Department of Planning and Zoning

TO: Development Review Board
FROM: Scott Gustin
DATE: February 17, 2015
RE: 15-0743CA/MA; 234-240 College Street

Request: Addition and renovations to existing building, addition of 4 residential units for a total of 23.

S SITE PLAN
SCALE: 3/16" = 1'-0"

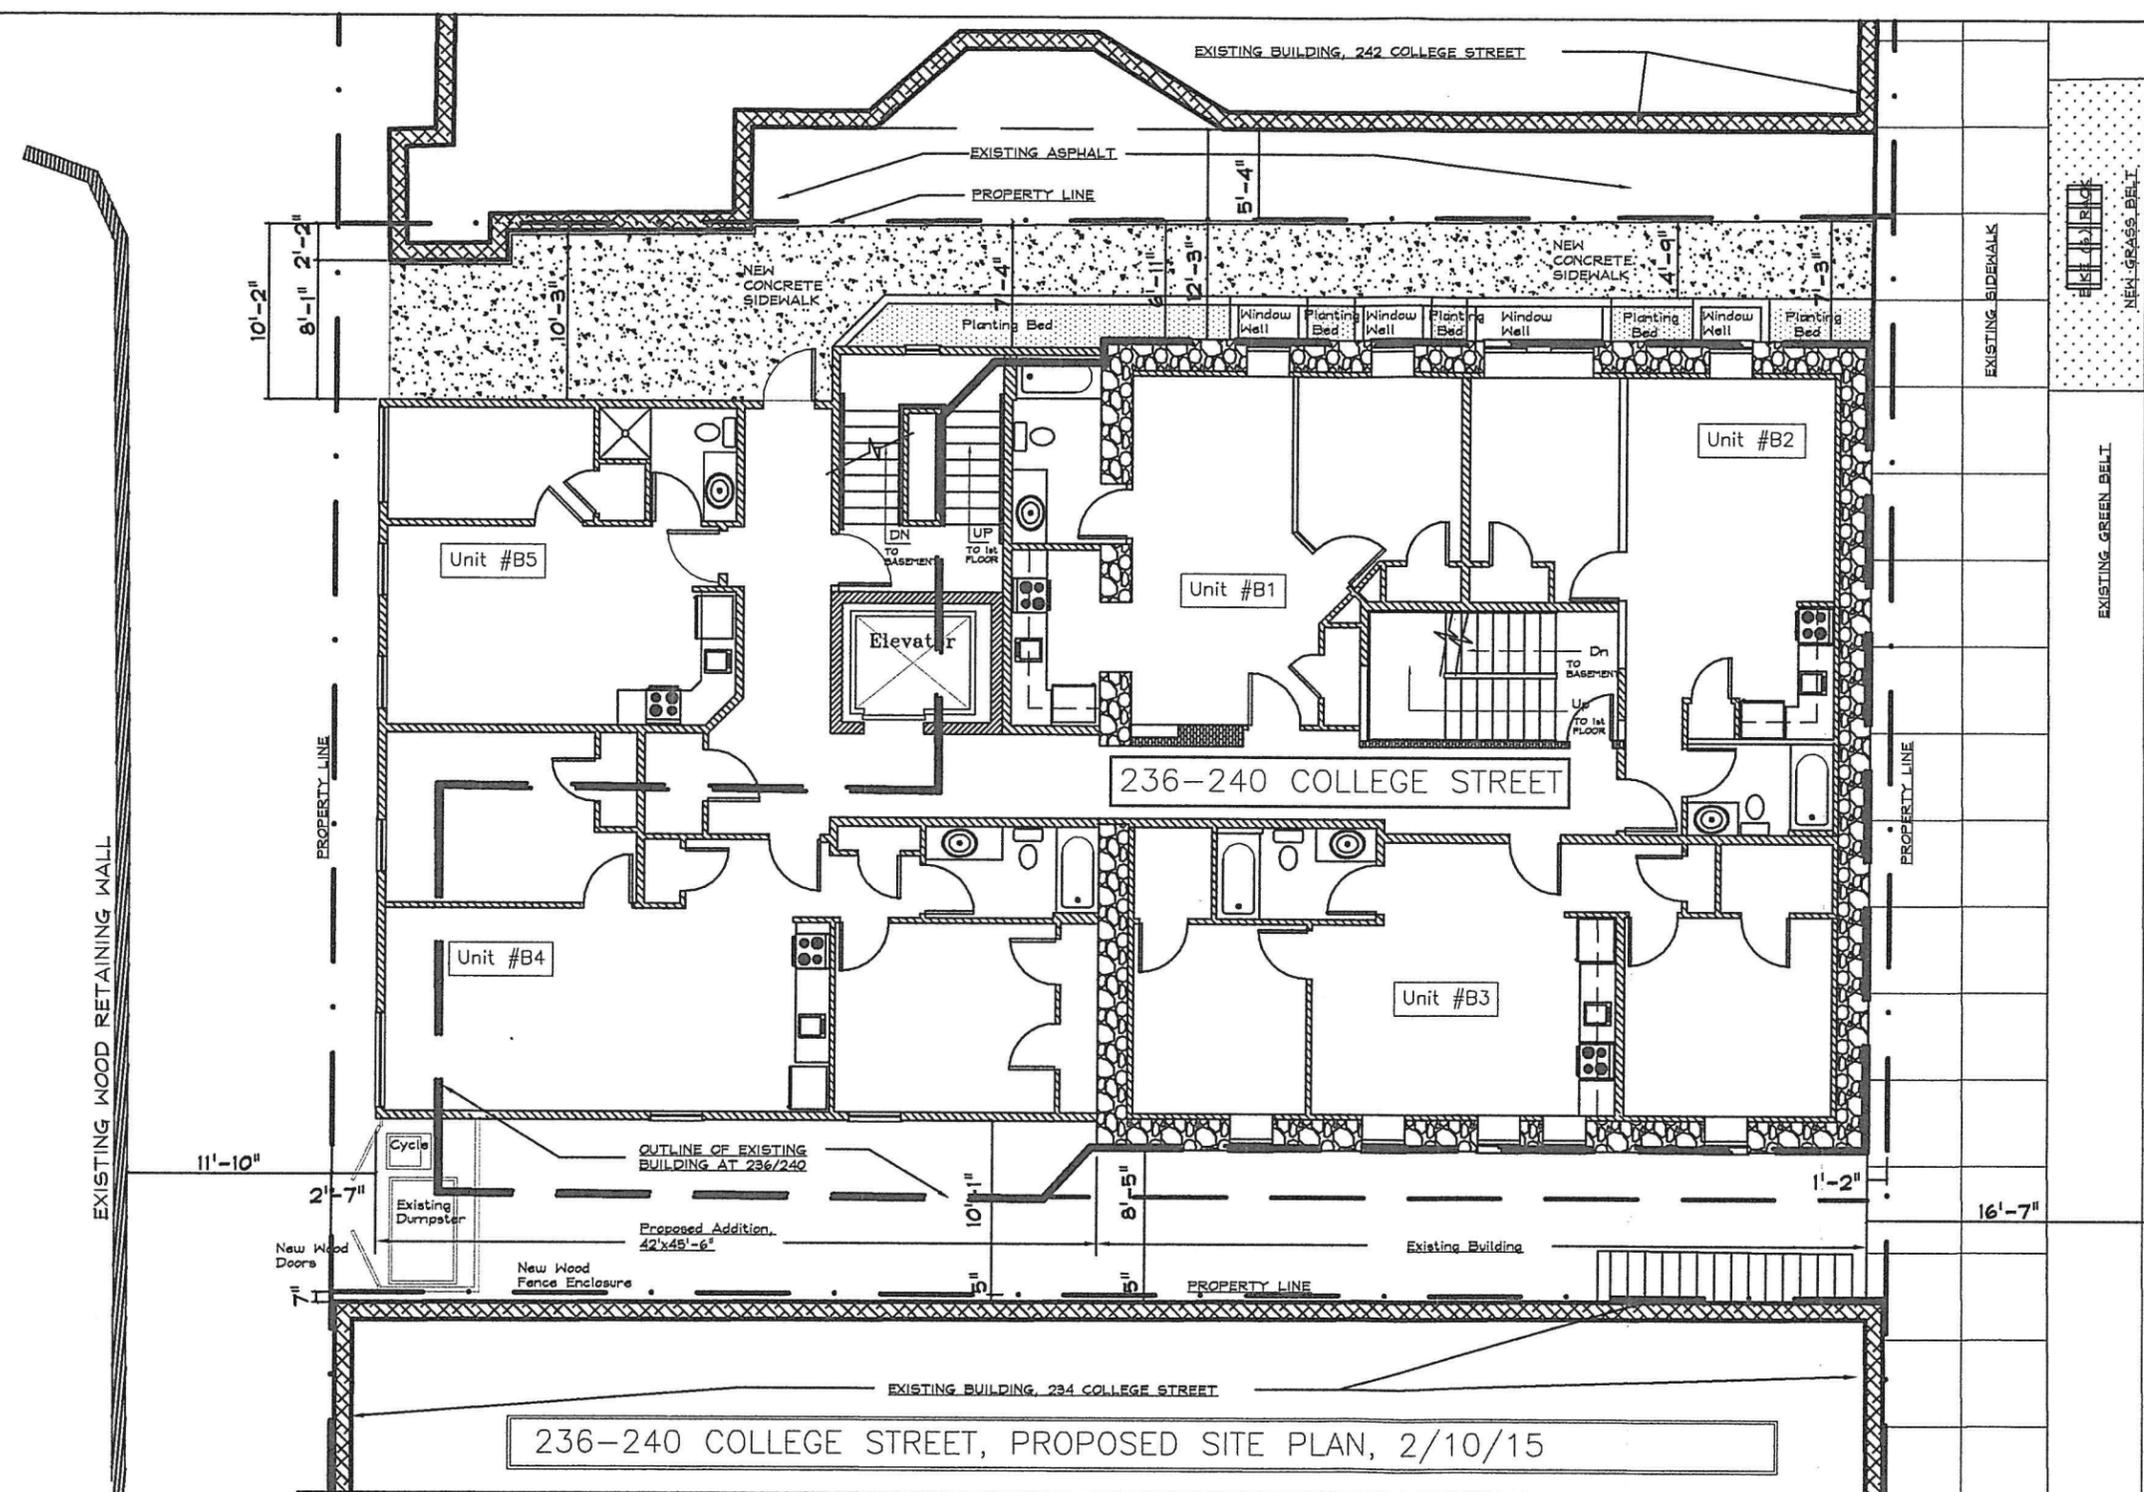
The site plan shows the reconfigured addition set back 10' 1" from the western side property line and 6' 11" to 10' 1" from the eastern side property line. As a result, windows are proposed, and allowed, on both sides and the rear of the addition.

This criterion requires a 10' setback in the event that neighboring buildings with doors or windows are built within 5' of a shared property line. Such is the case here. The neighboring building to the west is built to the shared property line. It has windows along the full length and width of the east-facing façade. As noted above, the site plan shows a 10' 1" setback for the proposed addition along this shared property line. Approximately the rear third of the neighboring building to the east is built within 5' of the shared property line. It has windows and doors along the full length and width of the west-facing façade. The site plan shows a 10' 1" setback for the new addition along this portion of the shared property line. **(Affirmative finding)**

While not considered as part of the minimum off-street parking requirements, it bears noting that the site plan depicts the street space in front of the newly closed curb cut as a tenant drop-off spot (i.e. 15-minute parking space). Such designation is subject to the review and approval by the Public Works Commission. Also, this space currently serves as a CCTA bus stop. The applicant has been working with the Department of Public Works and CCTA to make this 15-minute designation and to move the CCTA bus stop to the corner. **(Affirmative finding as conditioned)**

SHEET TITLE:
ELEVATION

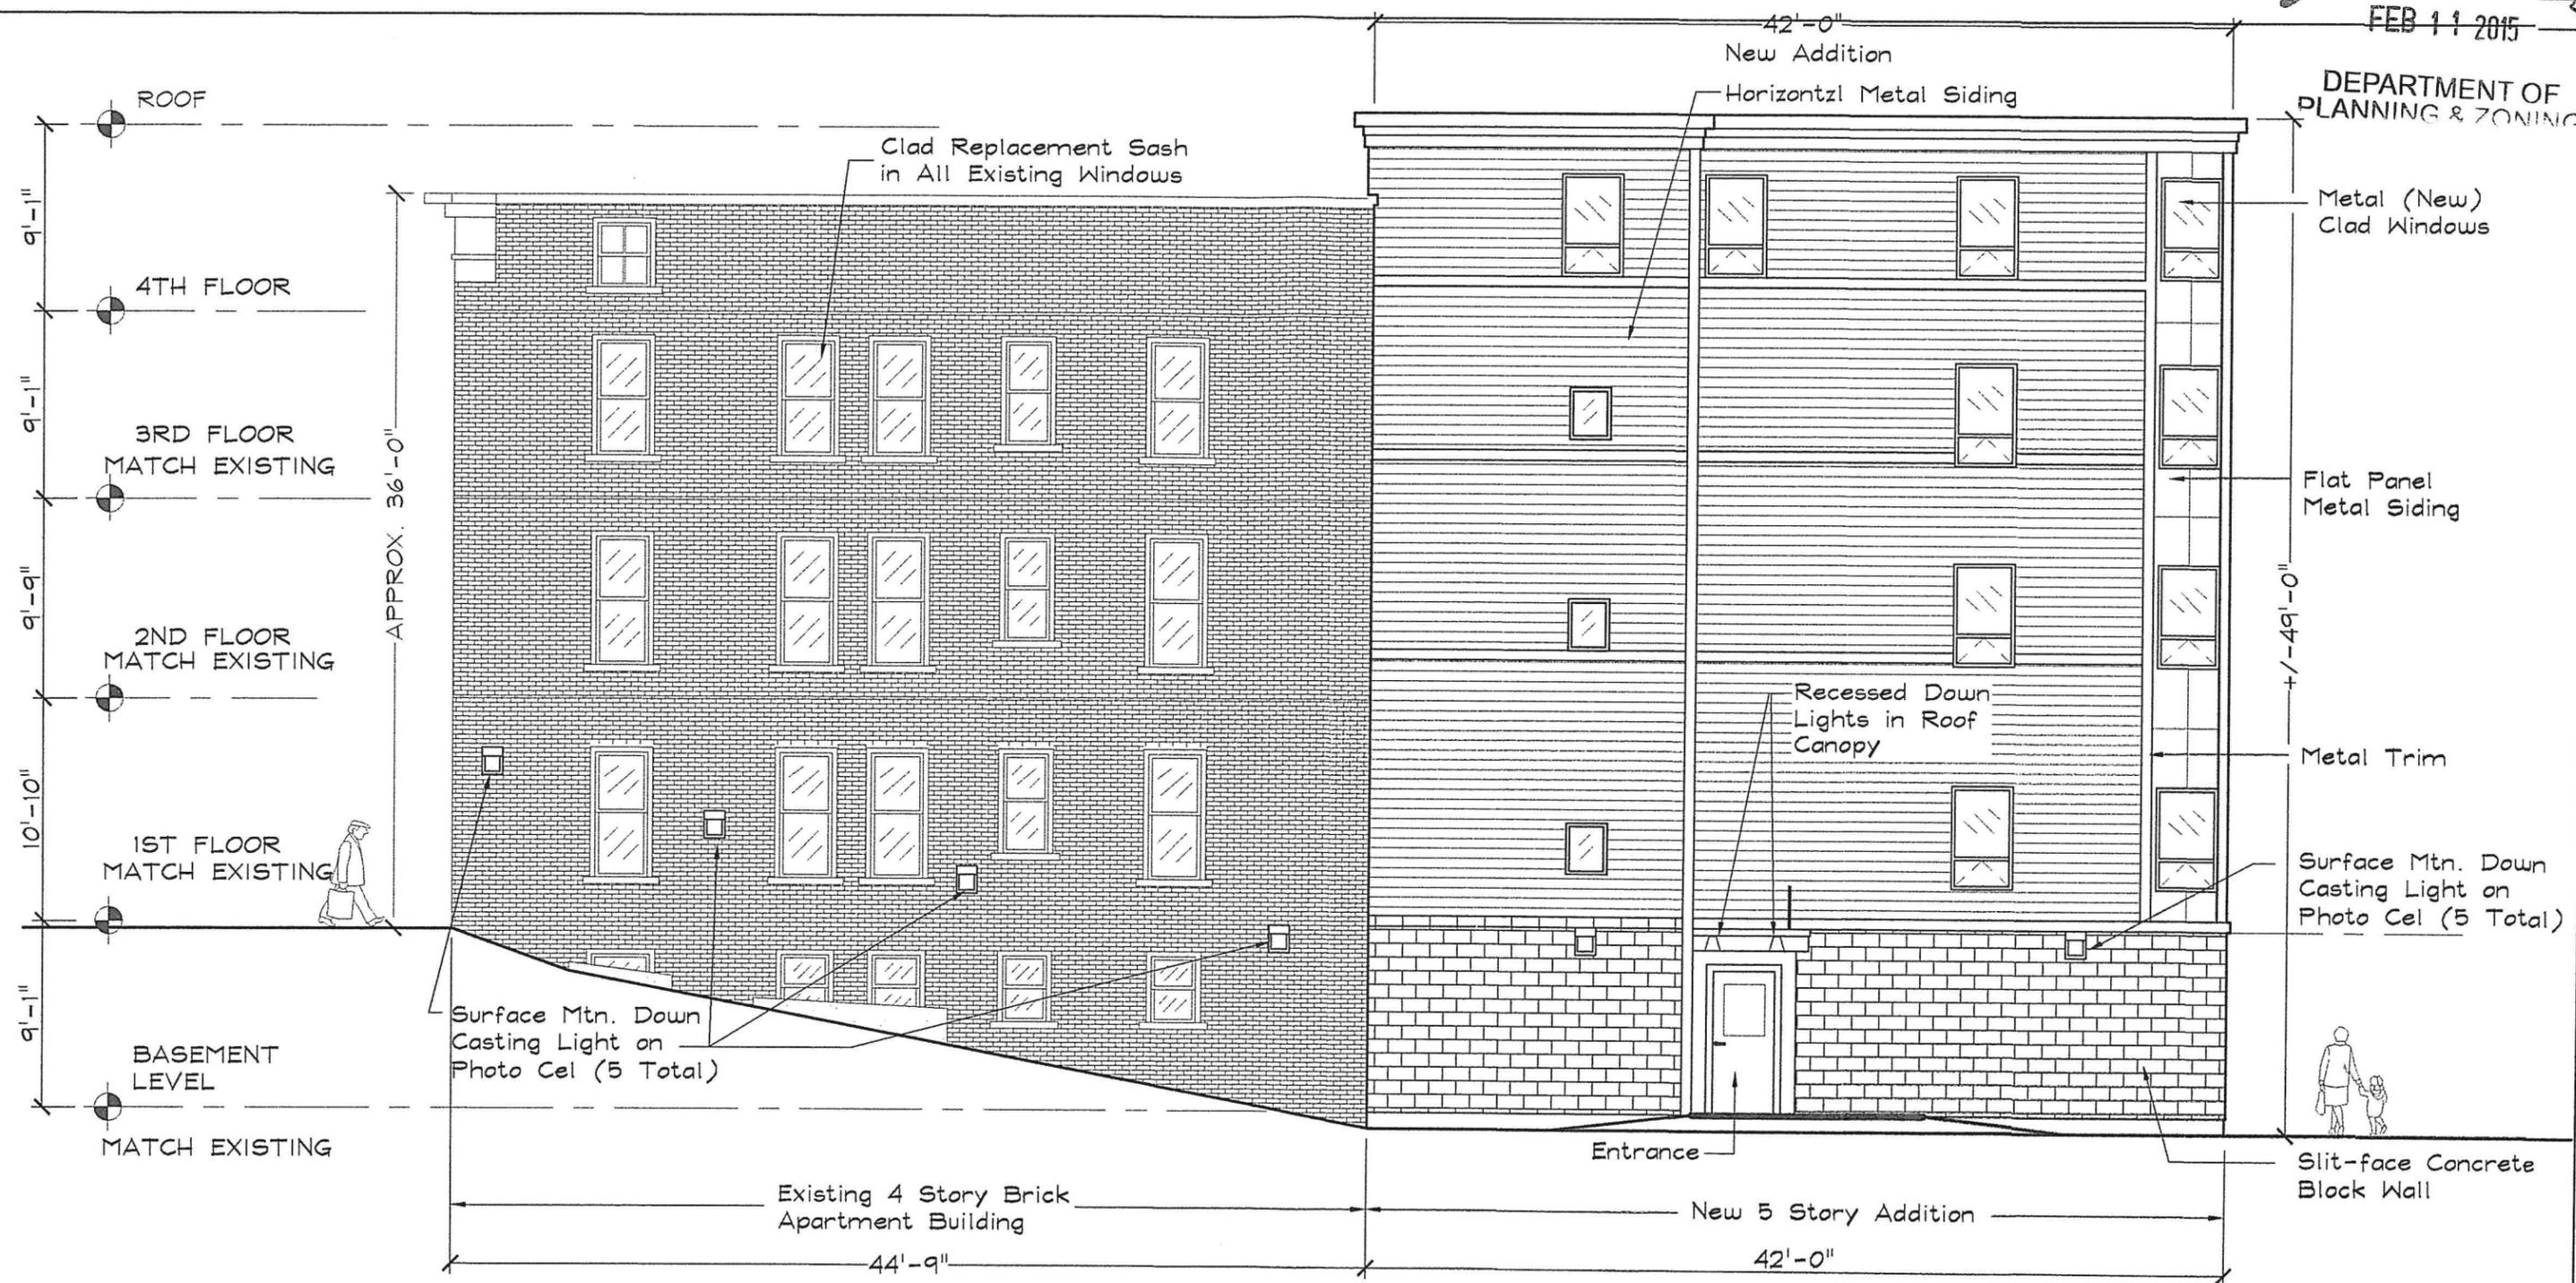
See Sec. 5.5.3 for stormwater management. The single doorway into the proposed addition will be sheltered under a canopy. Note that the canopy is only depicted on the east elevation. Its dimensions are unclear and must be noted. **(Affirmative finding as conditioned)**

2. **Prior to release of the zoning permit**, revised project plans depicting the following shall be submitted, subject to staff review and approval:
 - a. Side door canopy dimensions;
